**SUMMARY OF SITE INVESTIGATIONS  
AND RESPONSE TO THE EXPANDED  
SITE INVESTIGATION REPORT FOR  
LAND AND LAKES COMPANY  
NUMBER 3 FACILITY  
(122ND STREET LANDFILL)  
APPENDIX B VOLUME I**

RE: Land and Lakes #3  
#0316000034 - Cook County  
Addendum to Application for Significant Modification  
Log # 1995-060

The Addendum was prepared in response to Agency comments received by LALC. In order to facilitate the review of LALC's response to the Agency comments, this Addendum was formatted by presenting Agency comments in italics and LALC responses in standard text.

CONDENSATE SUMP  
N.T.S.

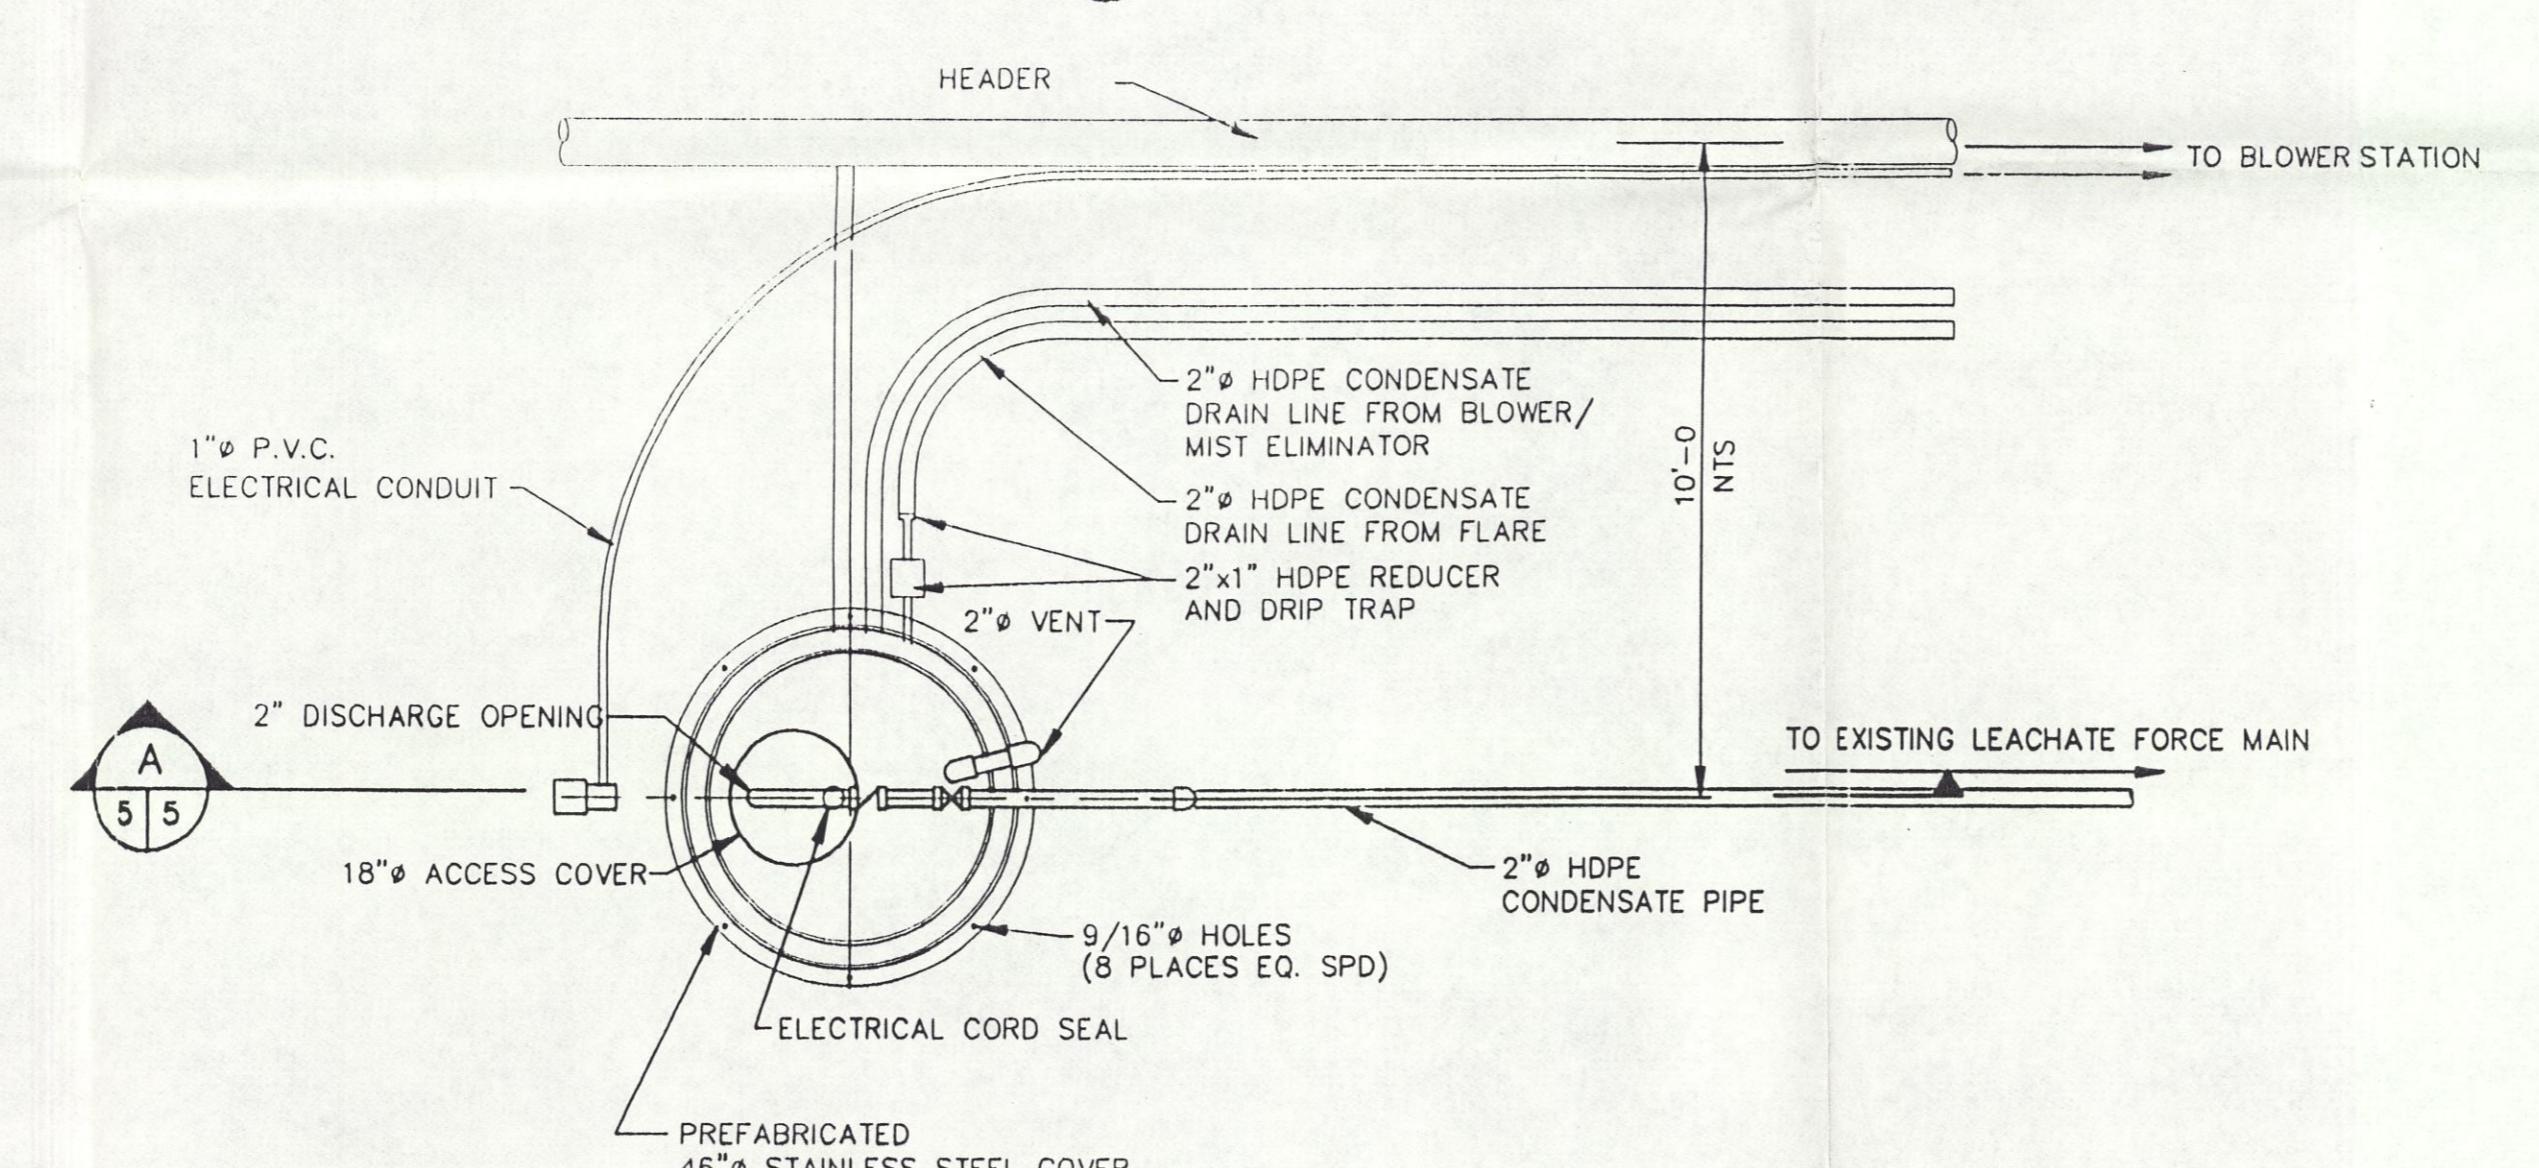
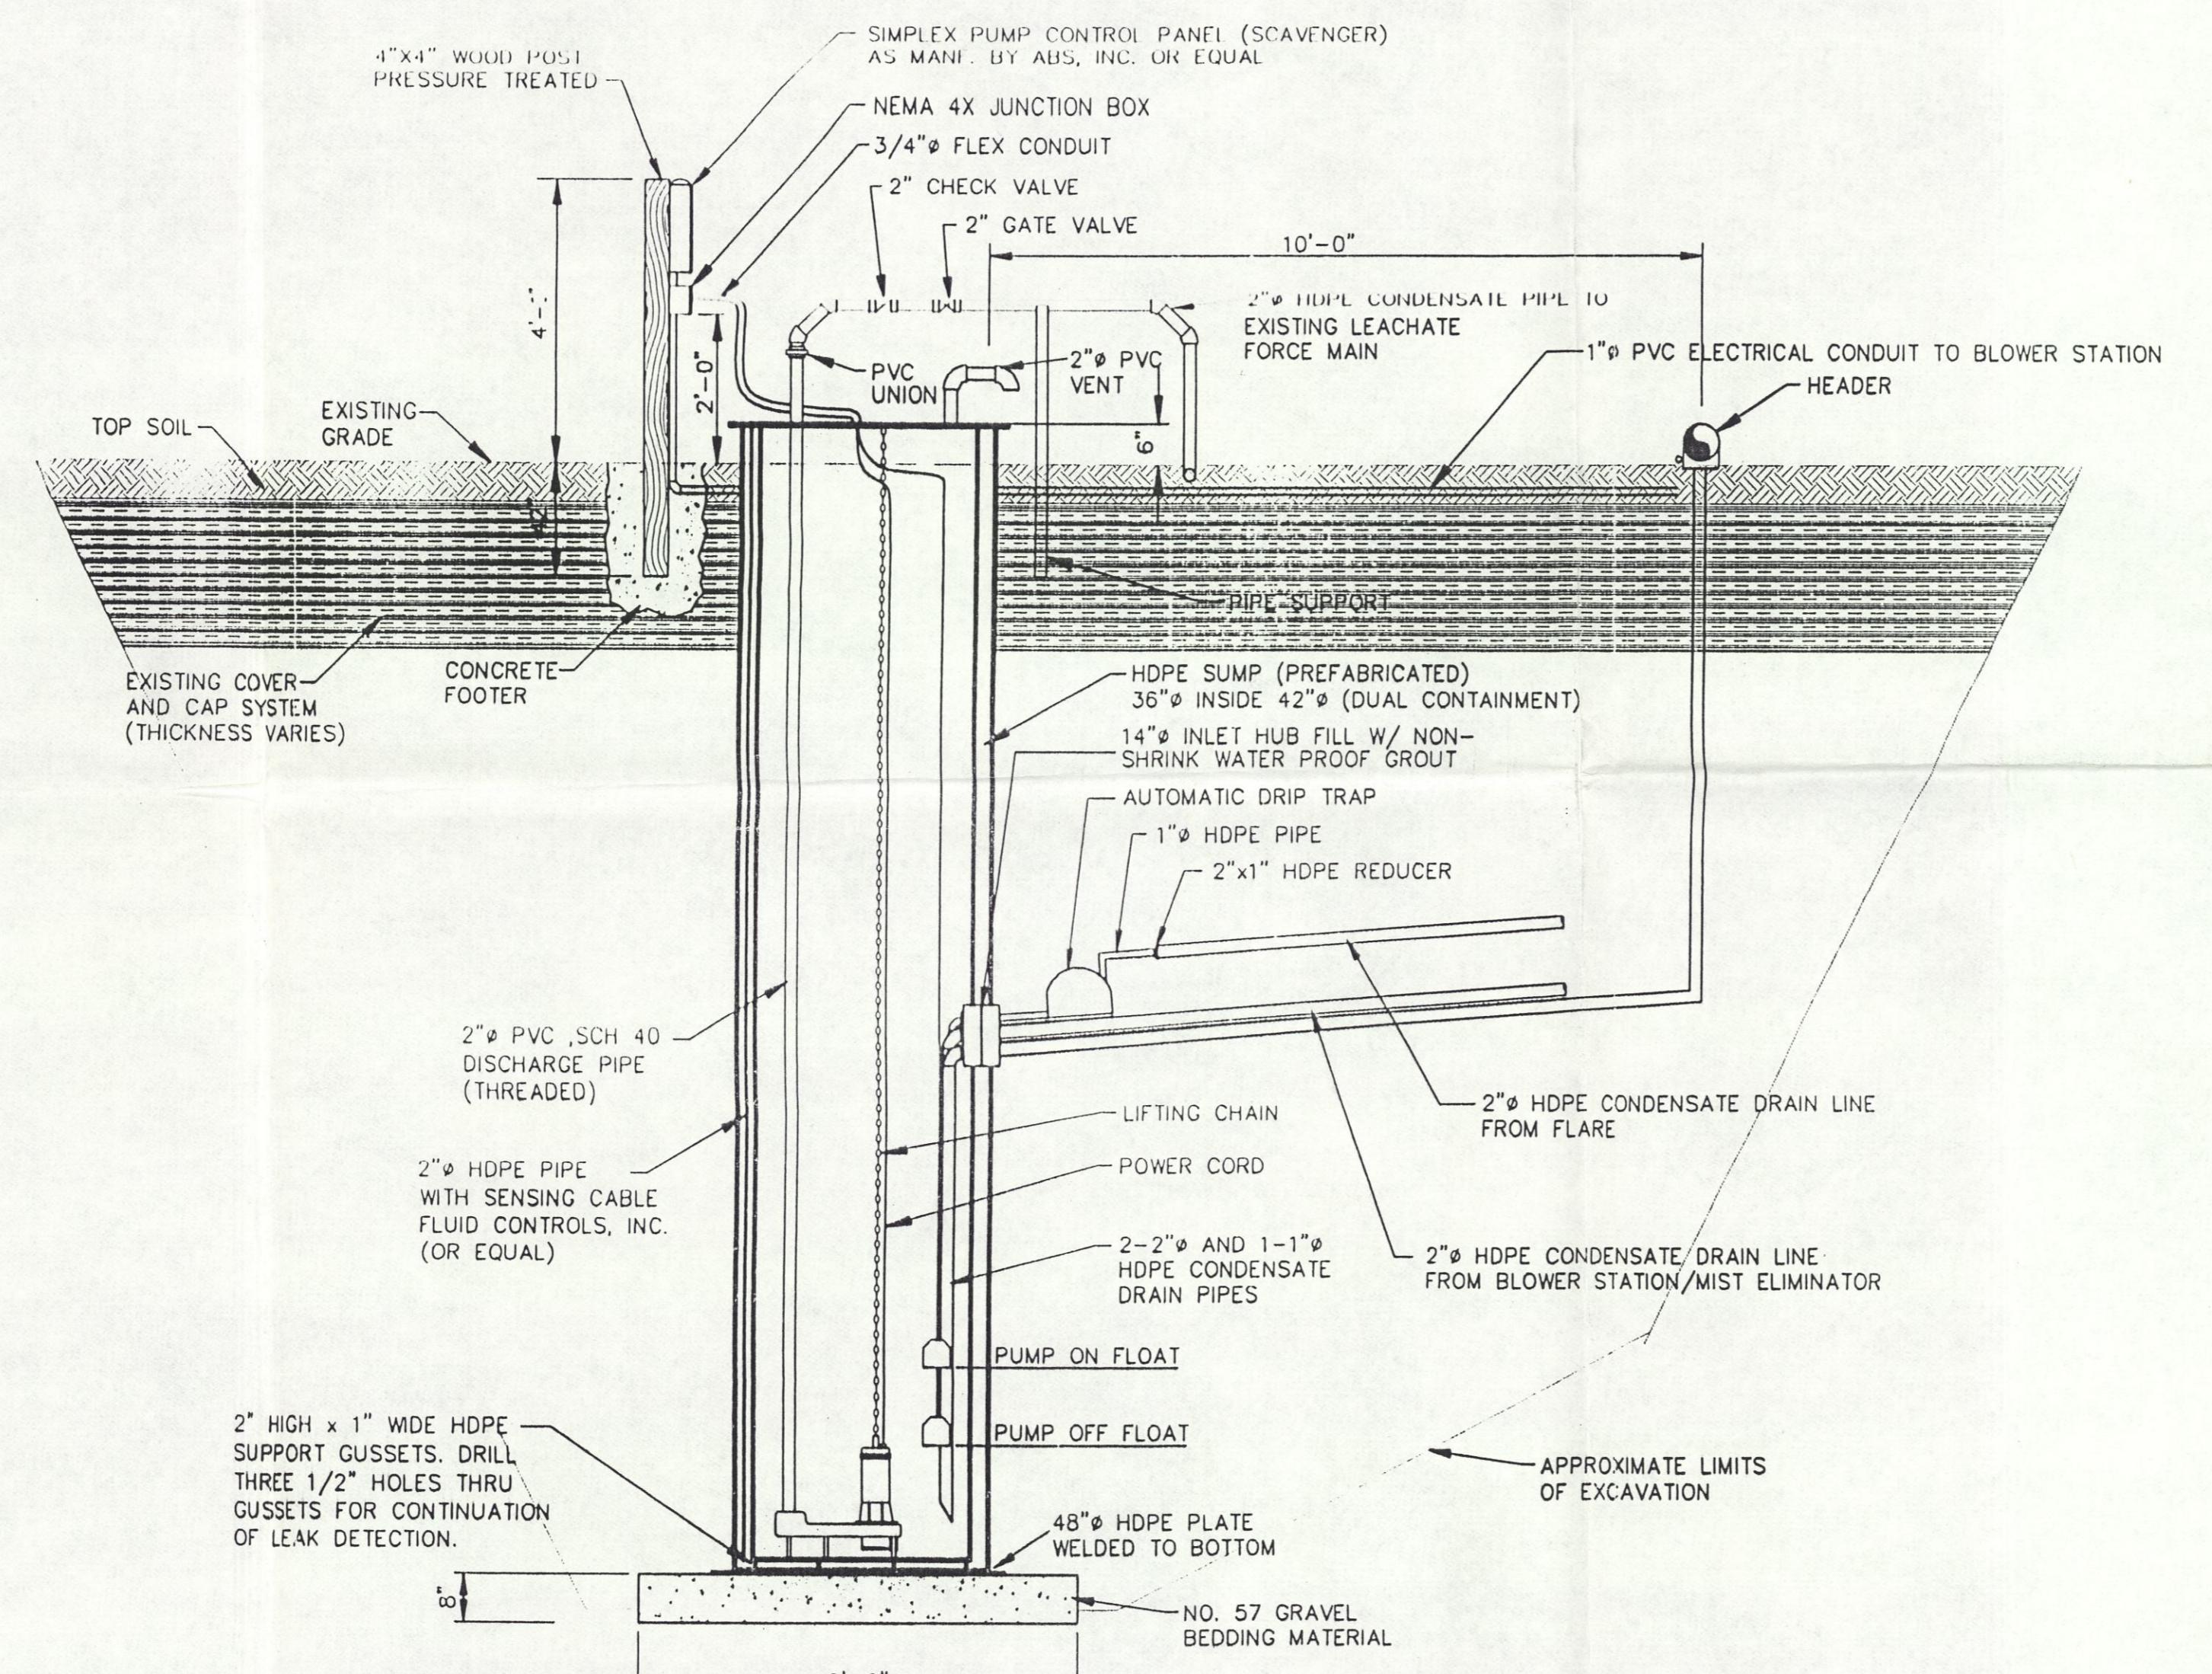
16. *The proposed condensate storage system, as shown on Drawing No. 4, does not appear to meet the requirements of 811.309(d) as required by 811.311(d)(8). Specifically, it does not seem to have secondary containment or a demonstration of adequate capacity.*

Secondary containment and an alarm system has now been integrated to the design, and will be installed for all condensate storage facilities located outside the limits of solid waste. Specifically, this pertains to the sump location located near the blower/flare station. See Drawing No. 5.
